Re: Murphy Creek East / Harvest Ridge PA Filing No. 3– Site Plan and Plat (DA-1250-54) (Case Numbers 1995-2002-10; 2021-4019-00; 2021-3039-00)

Thank you for your comments regarding the initial submittal of the Murphy Creek/Harvest Ridge Filing 3 Site Plan and Plat, which we received on June 10, 2022. We have reviewed all the comments and have addressed them in the following pages.

Figure 4.2-3: Motor Courts

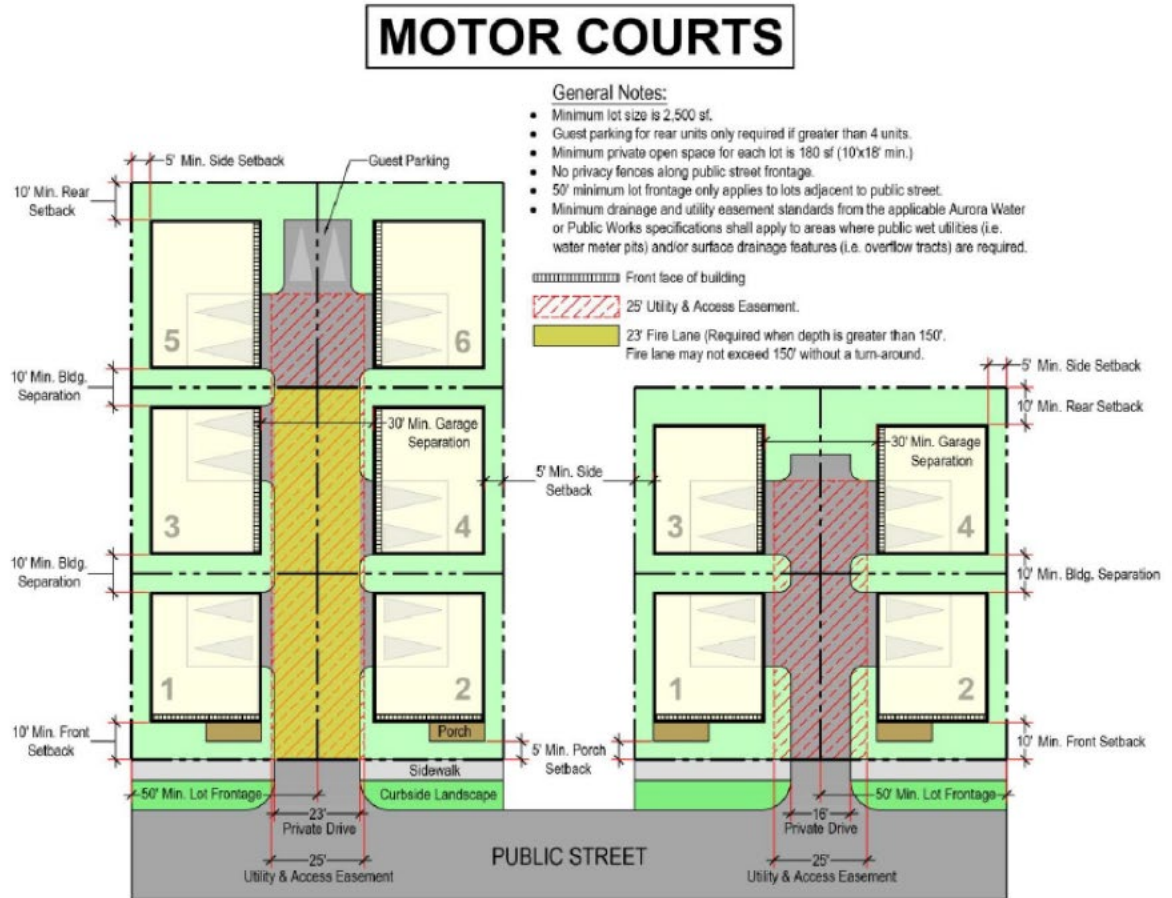
3I. As per the U.D.O. section 4.3.2.E, each Motor Court Dwelling development containing five or six dwellings shall include at least two guest parking spaces. Please include the guest parking in the next submittal.

3M. Please include a typical dimension. All garages need to be 30' away garage face to garage face for motor court products.

Response: Parking areas are indicated on the updated lot typicals, including garage space allowing for additional parking per motor court dwelling.

Response: This note has been added to the revised plans, with distance from garage face to garage face indicated.
